RECORD OF DECISION

Wantagh Cleaners
Operable Unit Number 2
Soil Vapor Intrusion Evaluation
State Superfund Project
Wantagh, Nassau County
Site No. 130064
March 2017

Prepared by
Division of Environmental Remediation
New York State Department of Environmental Conservation

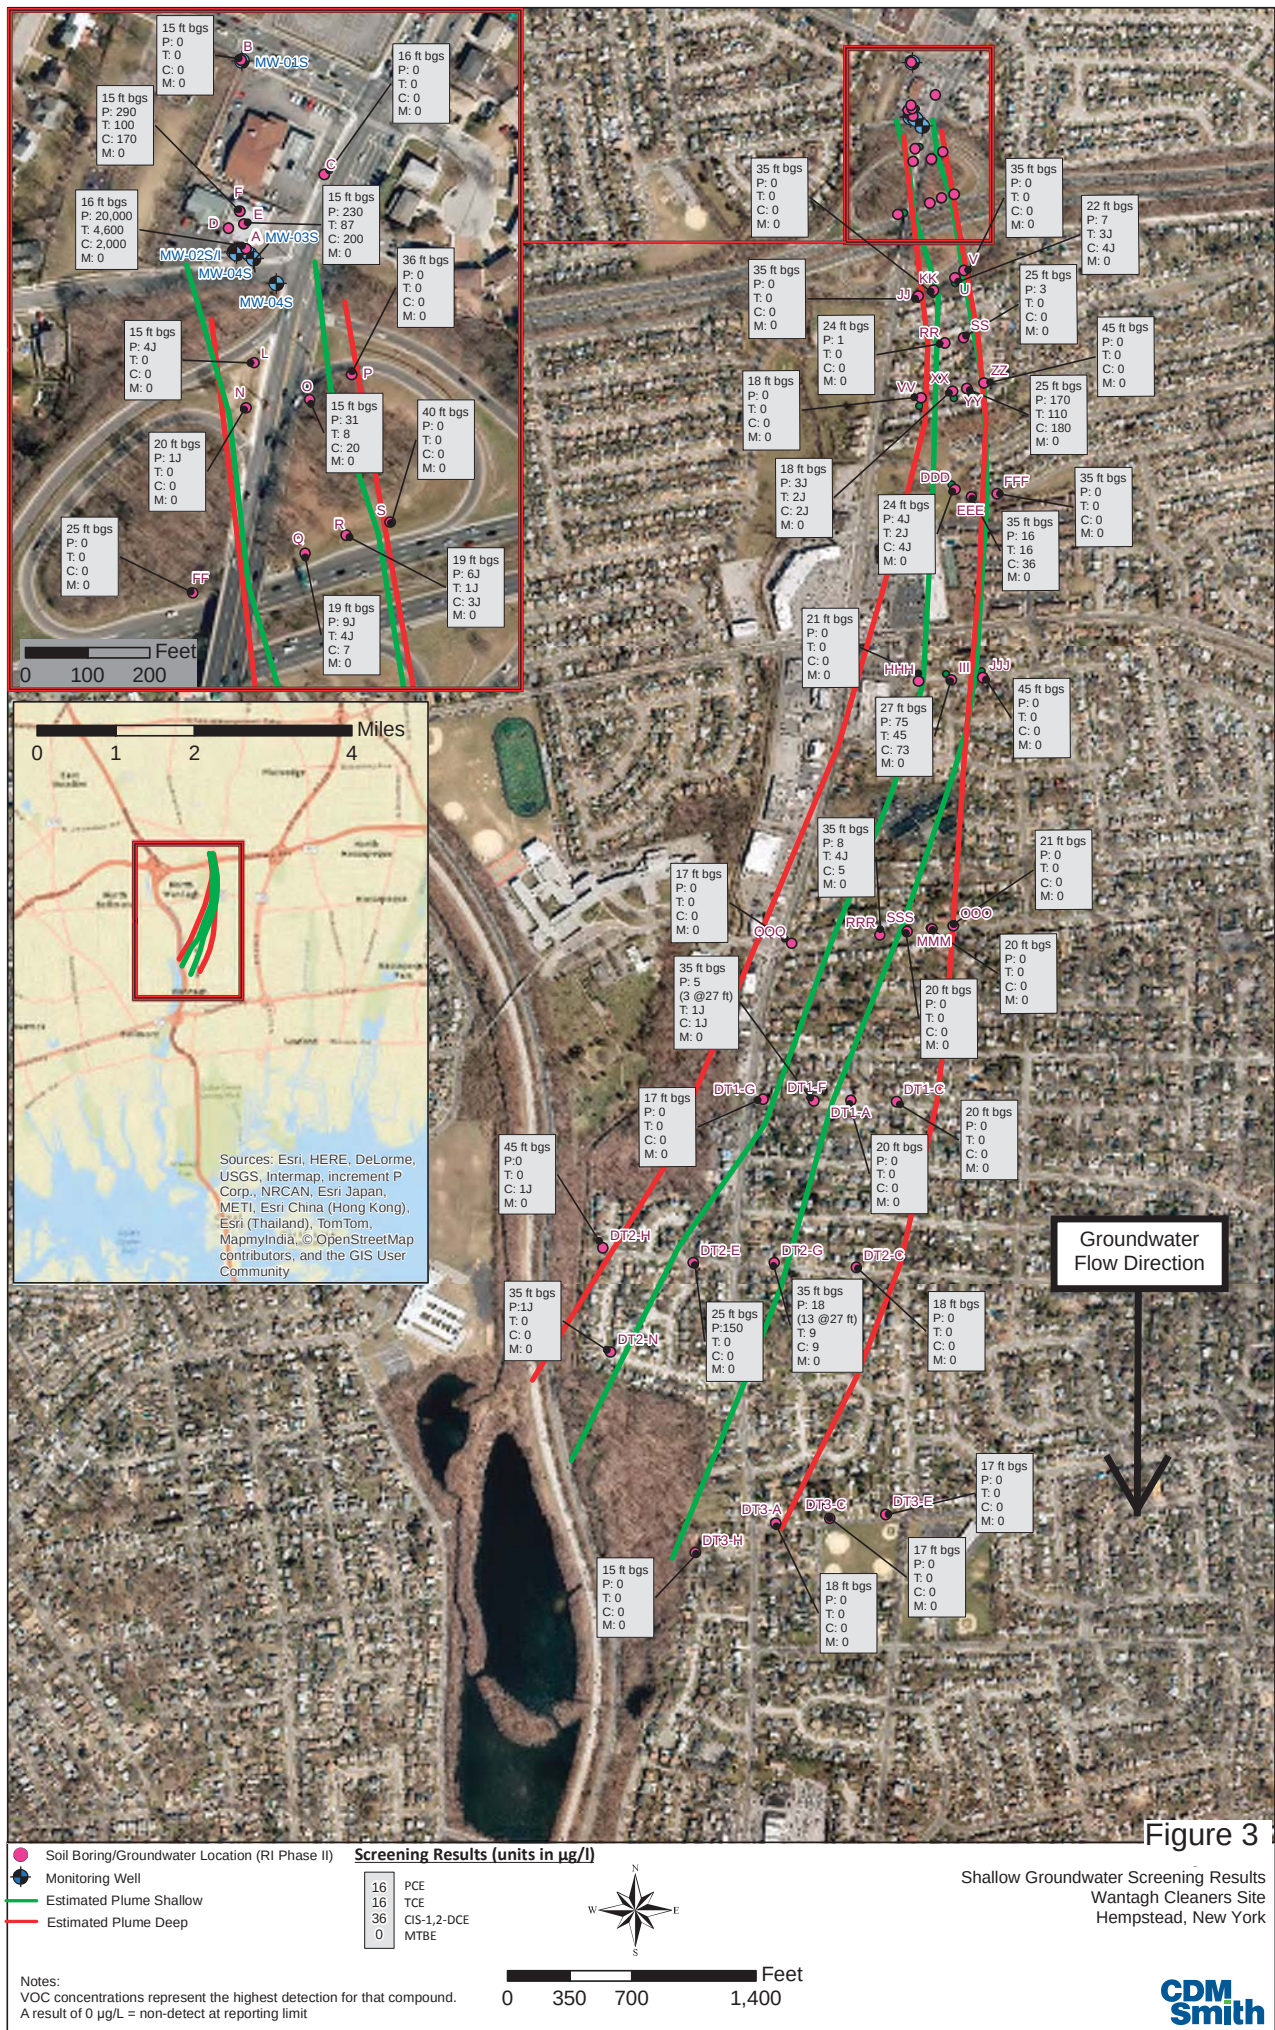
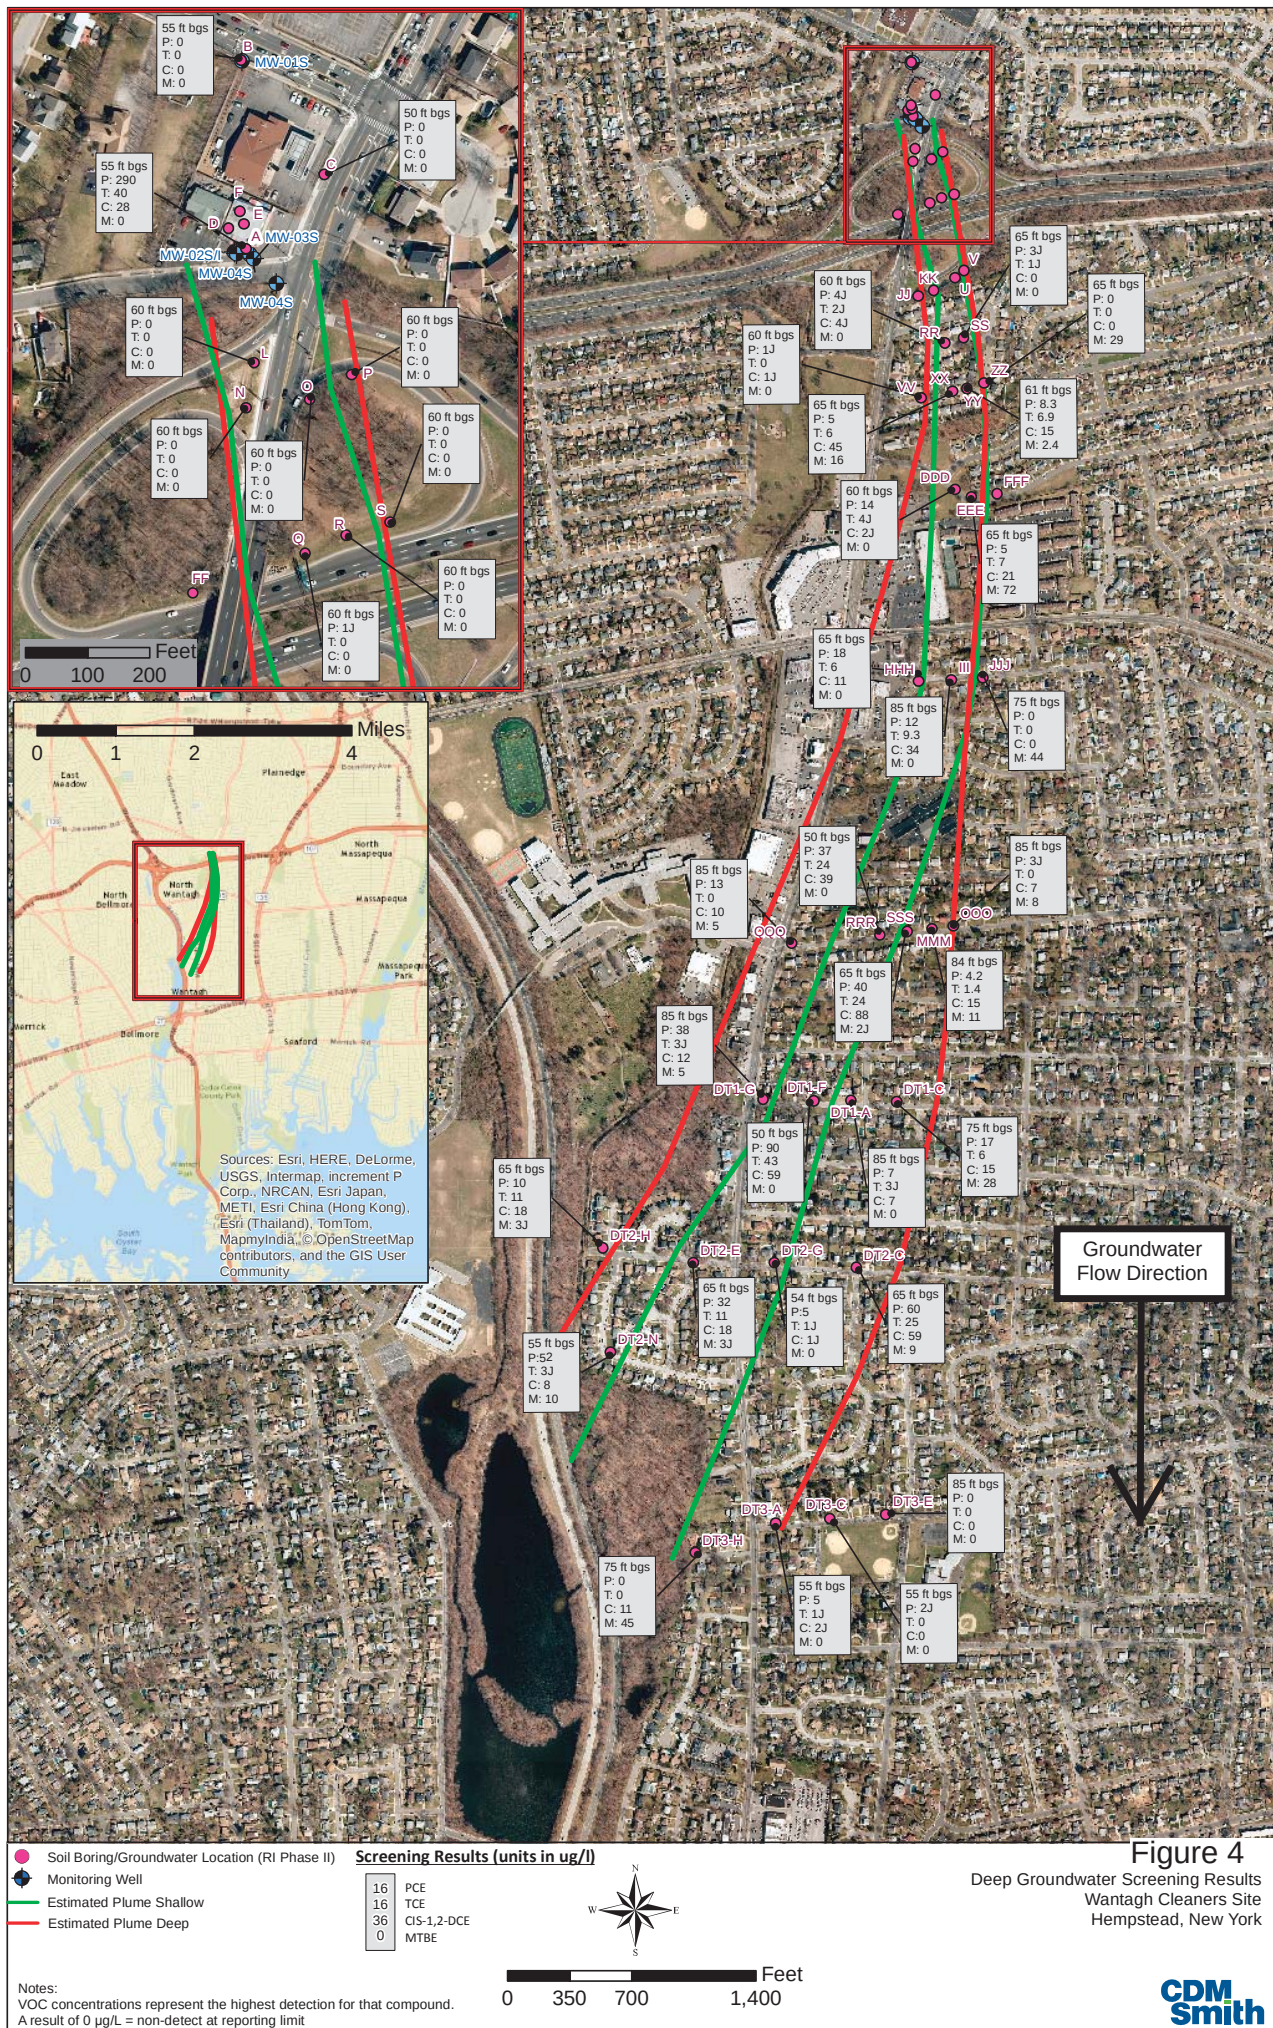
COMMENT 7: Is the plume heading south or southeast?

COMMENT 22: The monitoring well 1,500 feet off-site, which displayed the highest off-site concentrations of tetrachloroethene (PCE), trichloroethene (TCE) and cis-1,2-dichloroethene (cis-1,2 DCE) is not indicated with a name or location. The information provided states that this monitoring well is 1,500 feet off-site. We ask that further information is provided with the location of this well and all other off-site monitoring wells tested in the 2011-2014 remedial investigation study in order to better understand the migration of the contaminants.

RESPONSE 7: The overall groundwater flow direction is to the south in the immediate vicinity of the site. Further downgradient, the groundwater flow direction turns toward the south-southwest, in the direction of Newbridge Pond. Figures 3 and 4 in the Record of Decision illustrate the plume direction downgradient of the Wantagh Cleaners site.

RESPONSE 22: The sampling point referred to was sampled by direct push technology. There is no permanent groundwater monitoring well at this location. The sampling location is labeled as sampling point YY in Figure 3 of the ROD. For all off-site sampling locations, please refer to Figure 3 and Figure 4 of the ROD.
